TRAILS AT OVERLAND RANCH- FILING 01

SITE PLAN

SHEET TITLE:
TRACKING SHEET

TYPICAL LOT LANDSCAPE (50' LOT)

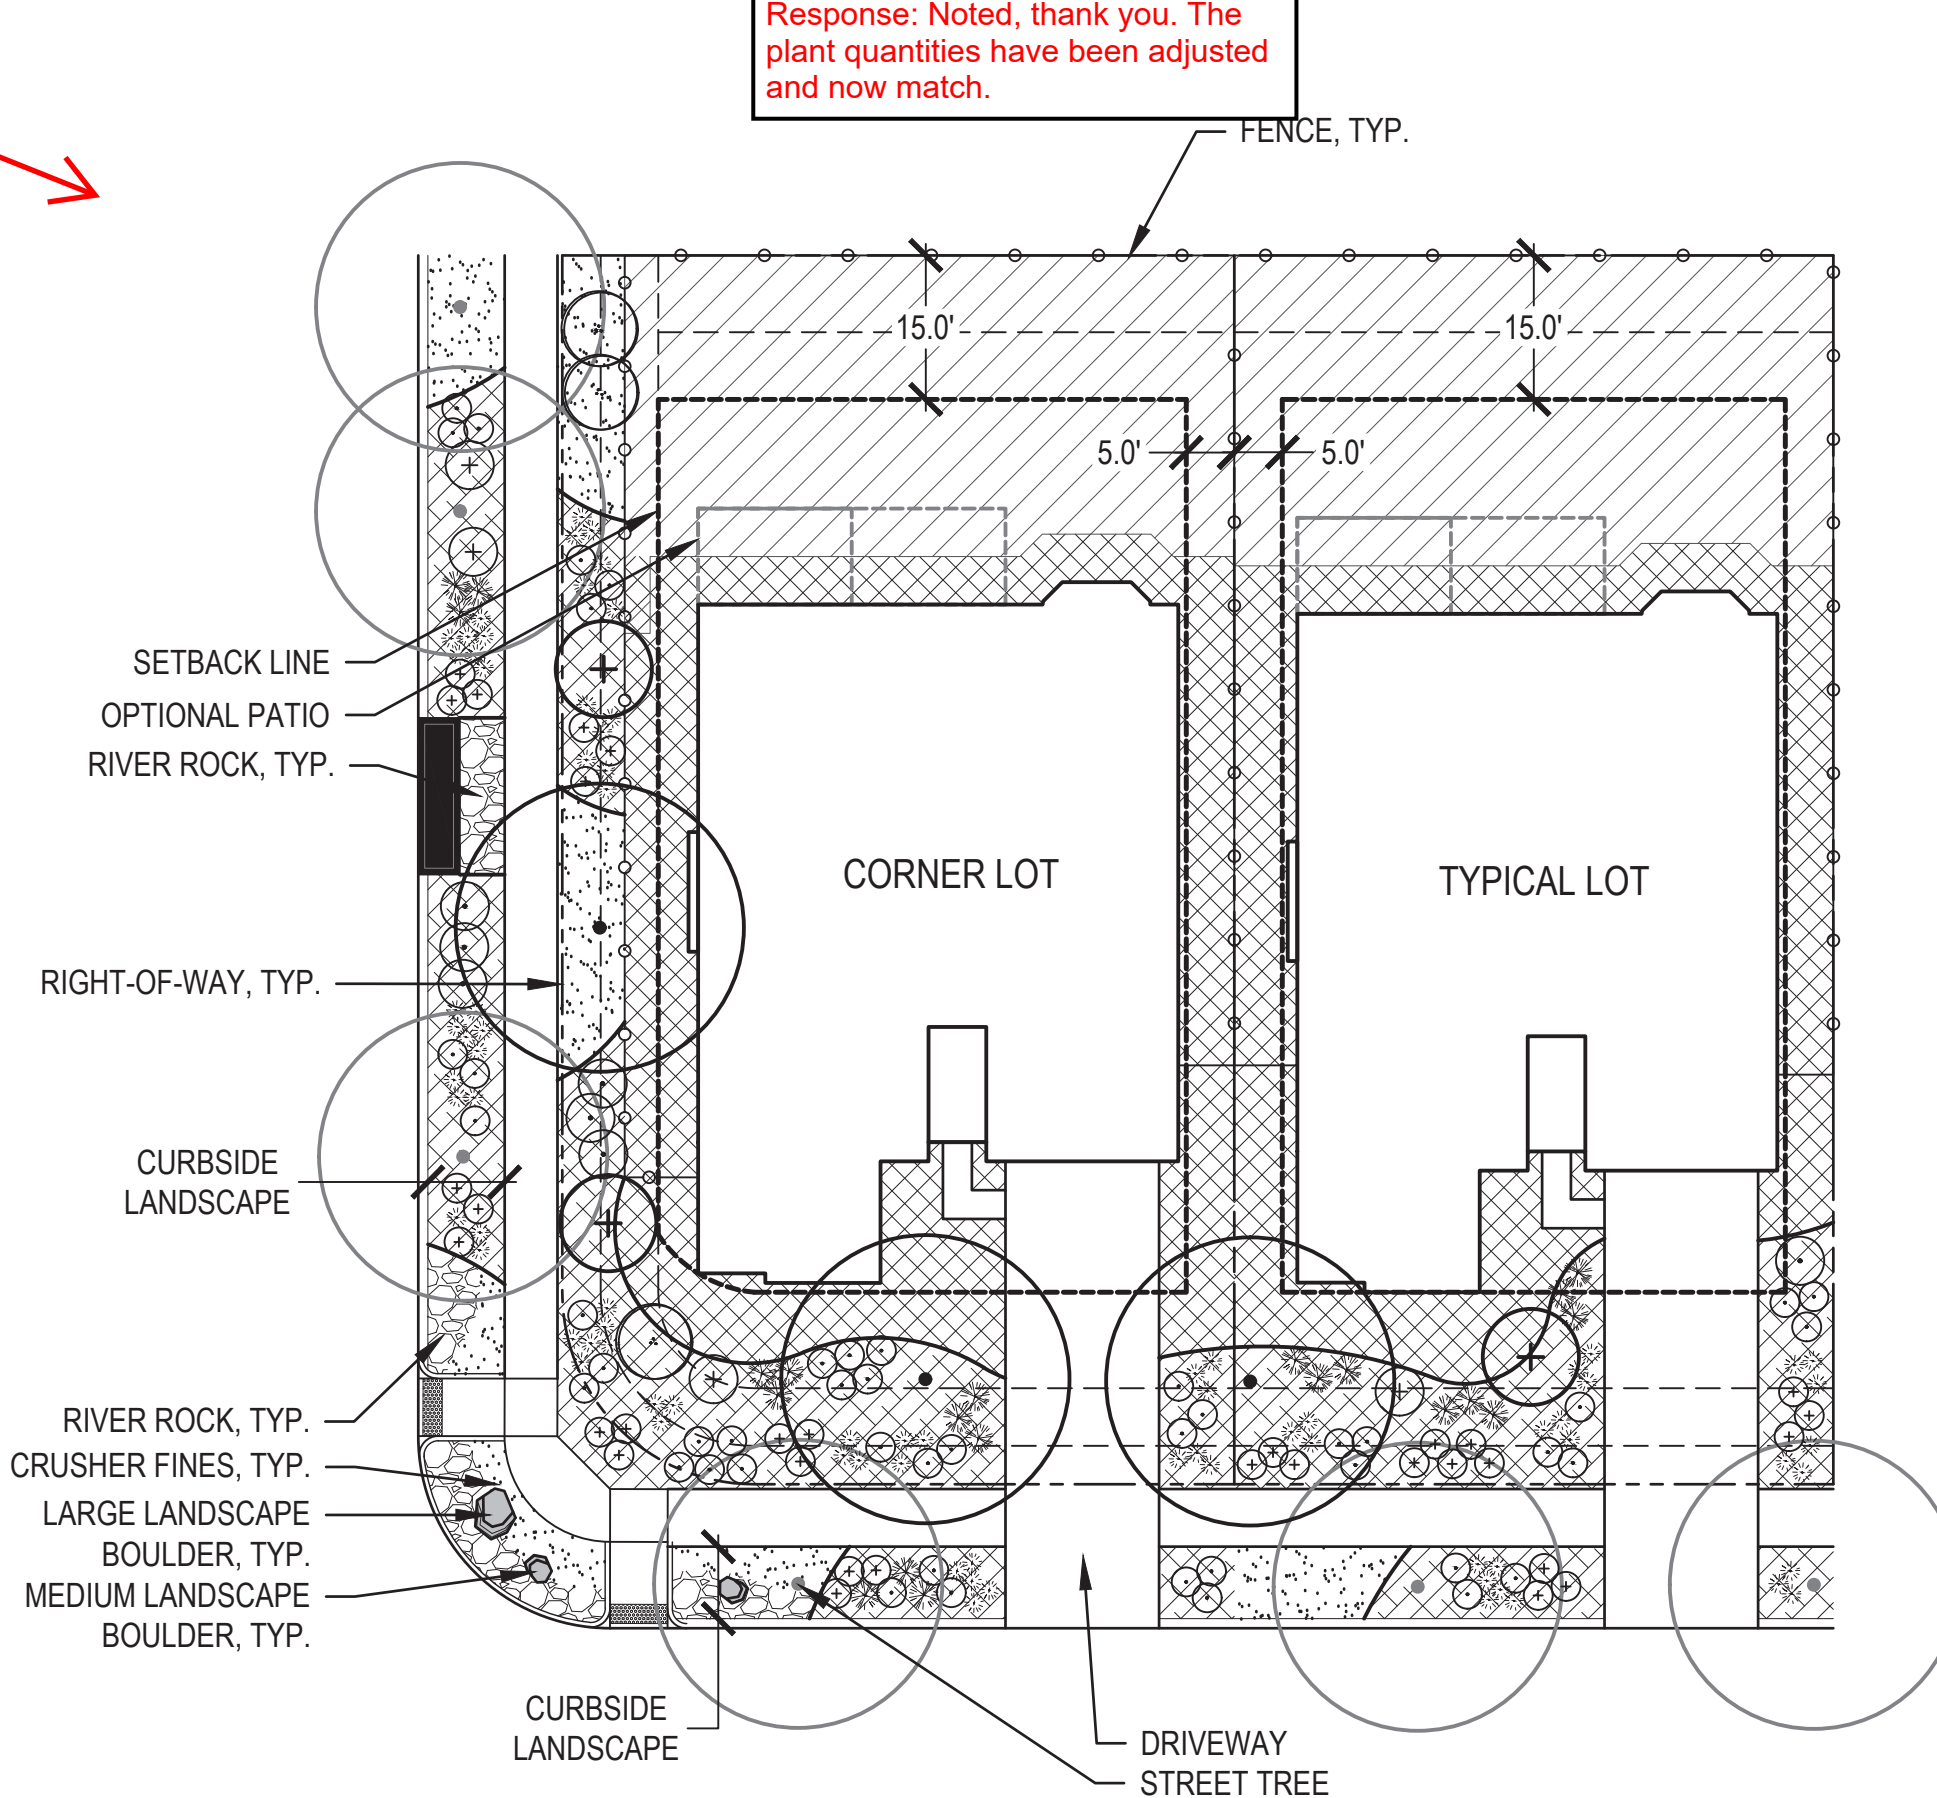
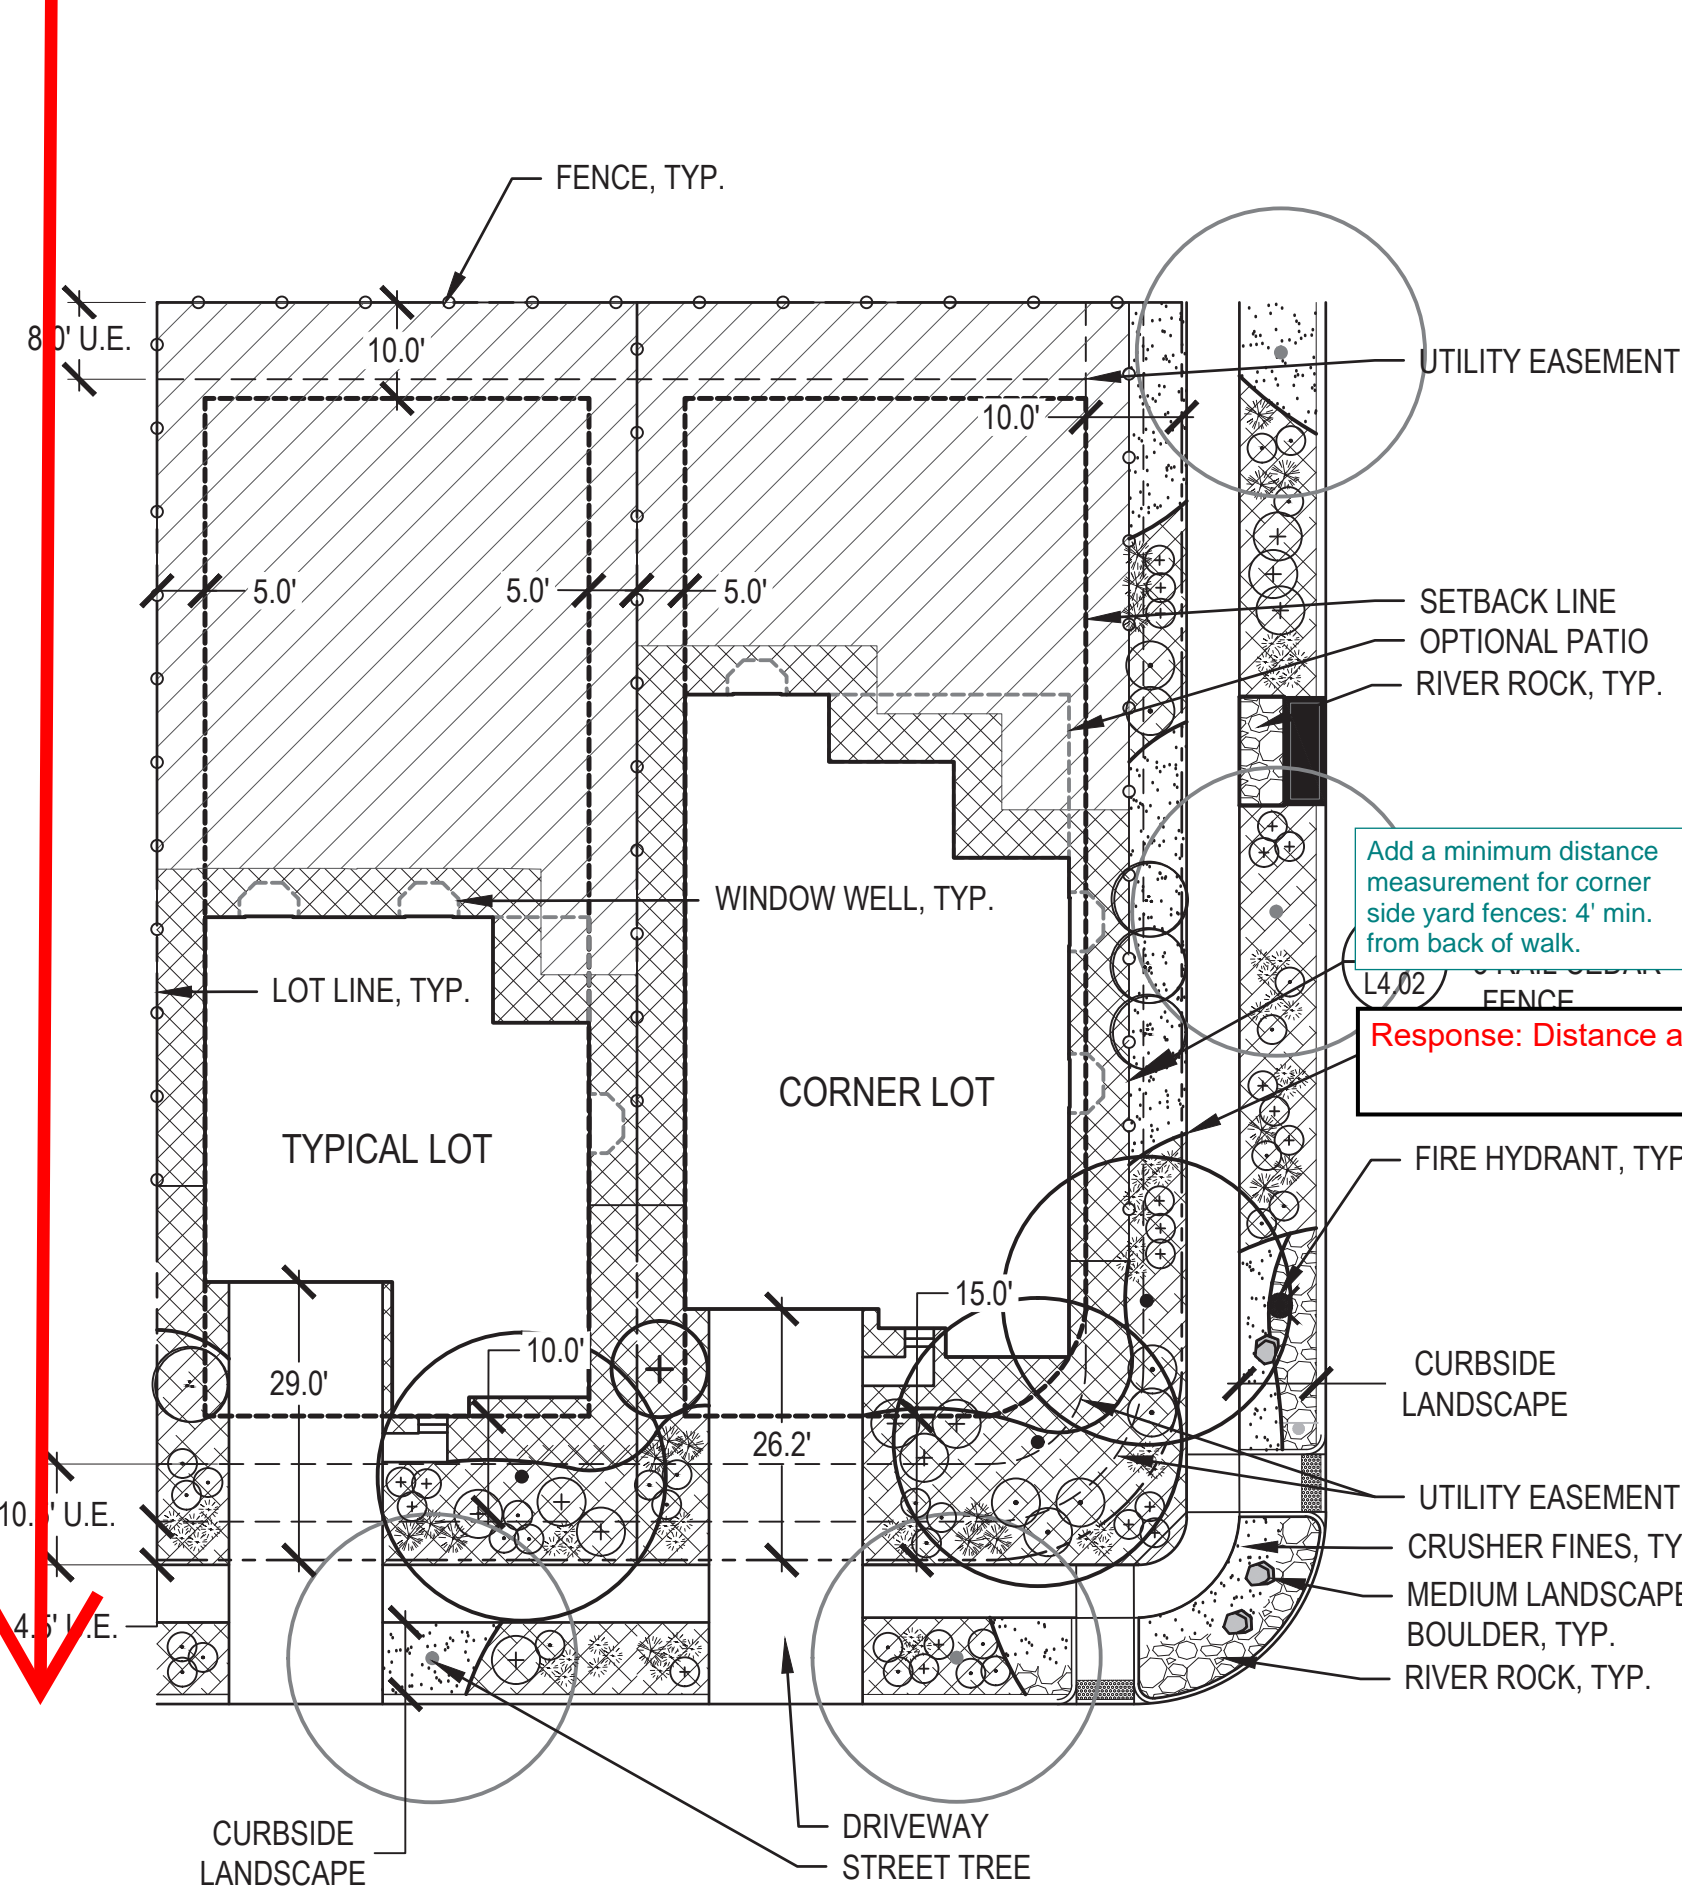
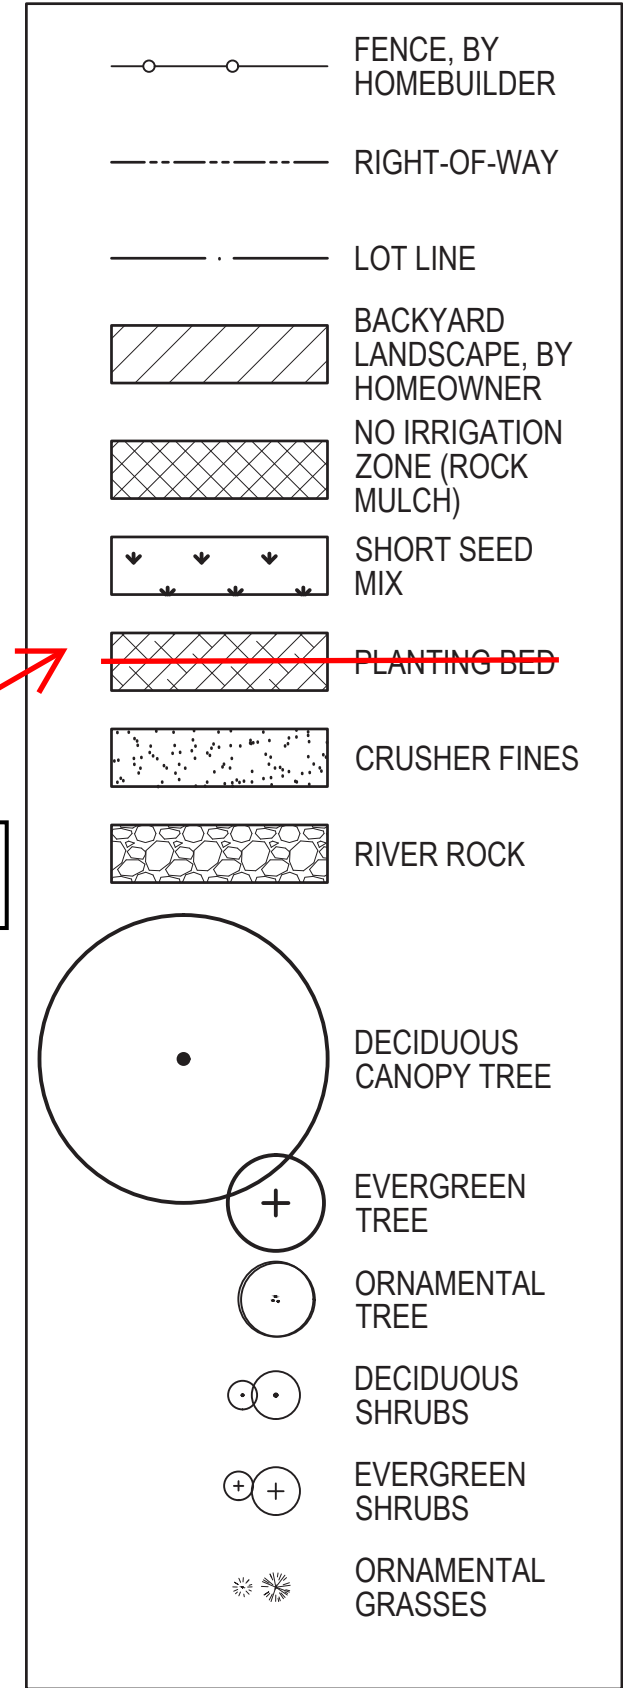
The lot plant quantities here and on the next sheet do not match and there are different quantities being provided for the same lots

This description doesn't match the plant schedule on the next page. Deciduous trees are listed as 2.5".

Remove the planting bed from the lot typicals and the legend.

Do not include a hatch for the planting bed.

Response: Noted, thank you. The lot typicals and plant quantities have been adjusted and are in compliance with Aurora City Code.

Response: Noted, thank you. The tree caliper size has been updated to 2.5"

Response: Noted, thank you. The hatch has been frozen.

Response: Noted, thank you. The plant quantities have been adjusted and now match.

Response: Noted, thank you. The hatch has been frozen.
